Page 1. This is the first of 4 pages illustrating the wiring changes to take an existing SPA-400 installation and rewire it for a SCI-4 intercom. The illustration below is of the original SPA-400 installation.

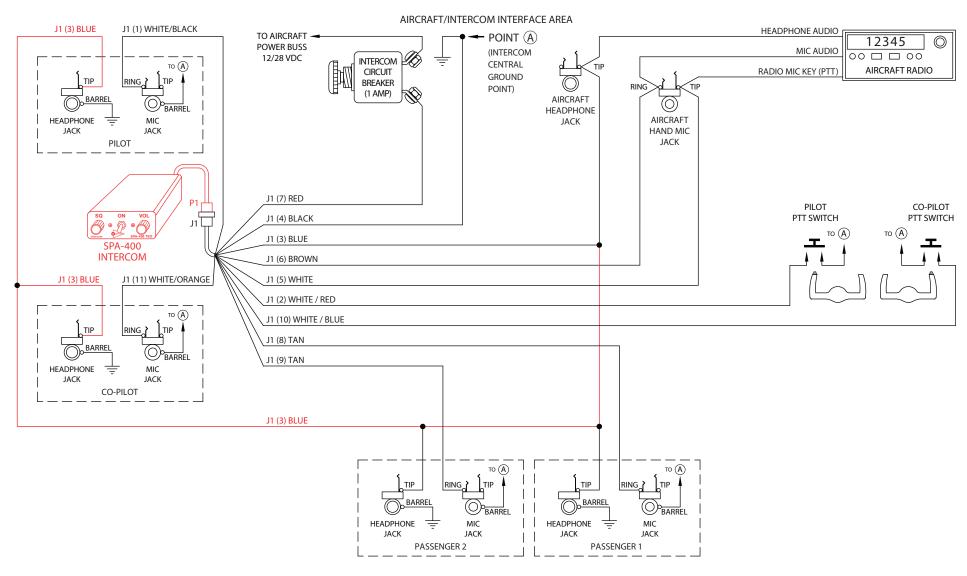
Page 2. Disconnect the tip terminal of the pilots headphone jack from the blue wire. Make sure that the **J1 (3) Blue** wire is still connected to the tip of the radio headphone line. Disconnect the copilots headphone jack tip terminal.

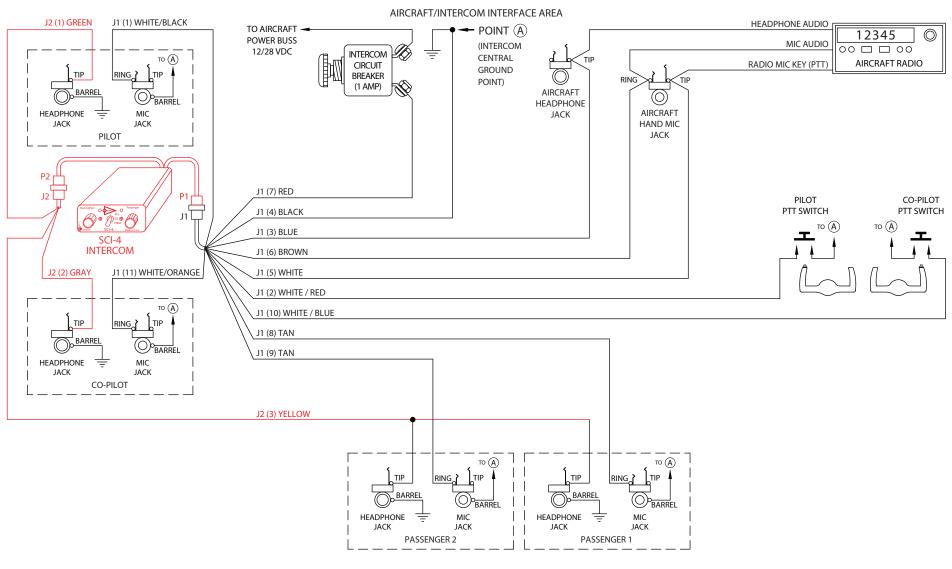
Page 3. Use the 4 foot headphone / intercom interface cable **J2** and connect the pilots headphone tip terminal to **J2 (1) Green**. The passenger headphone jacks are connected to **J2 (3) Yellow** of the interface harness. **J2 (2) Gray** of the headphone / intercom interface harness **J2** is connected to the copilots headphone tip terminal.

The SCI-4 intercom is connected to the new 3 pin interface harness J2 and the existing harness J1 of the original SPA-400 installation.
